Technical Service Bulletin: tsb100667

Replacement Information - Fuel Transfer Pump Assemblies

Figure 1, Fuel Transfer Pump Assembly -(1) Gasket, (2) Fuel Transfer Pump, (3) Mounting Support, 4) Capscrew

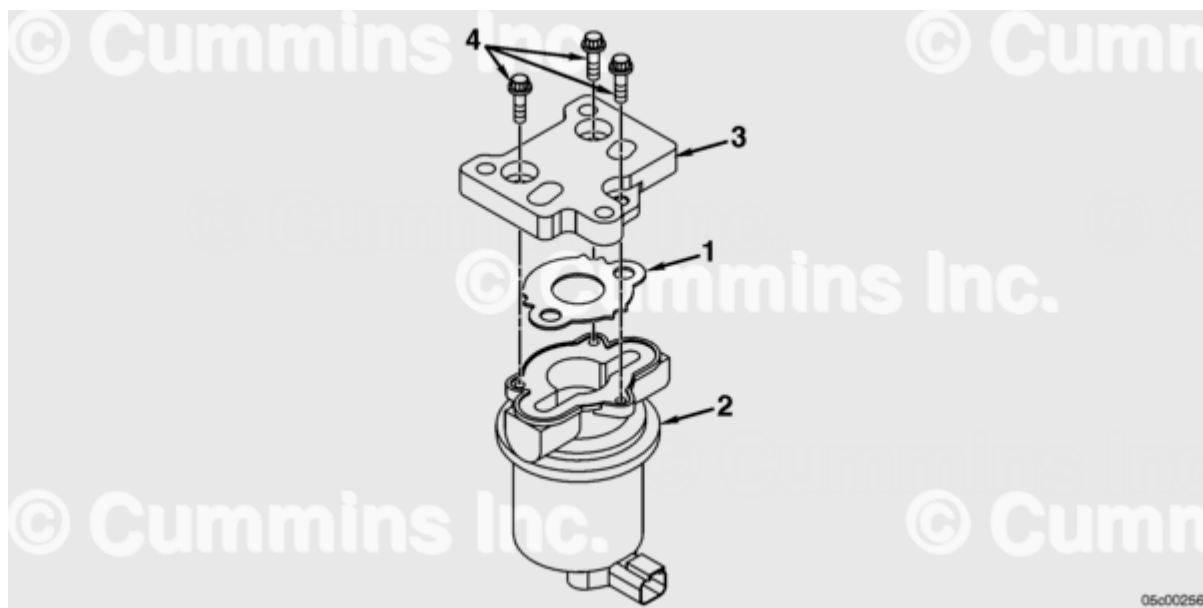
ISX transfer pump assemblies consist of a fuel transfer pump and a mounting support. See Figure 1.

Fuel Transfer Pump, Part Number 3964381, has been superseded by Part Number 4935013. The fuel transfer pump is **not** available for purchase alone, but it is used in many transfer pump assemblies. The major difference in the assemblies is the mounting support. When an obsolete

ISX transfer pump with no superseding part number is encountered, the correct replacement part number can be determined by reading the number on the transfer pump mounting support. Use the table to determine the correct fuel transfer pump assembly part number.

The mounting support design can vary from the one shown in Figure 1.
